Steering Column Rattle Noise

Market USA

| YEAR(S) | MODEL(S) | ADDITIONAL INFORMATION |
|-------------|----------|------------------------|
| 2009 – 2011 | Venza | |

Figure 1.

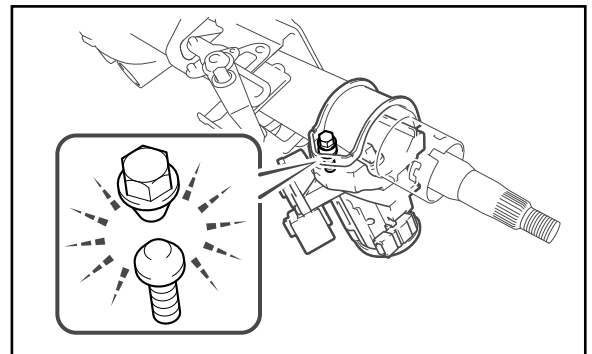
Be sure to use new tapered-head bolt and tighten the tapered-head bolt until the bolt head break off.
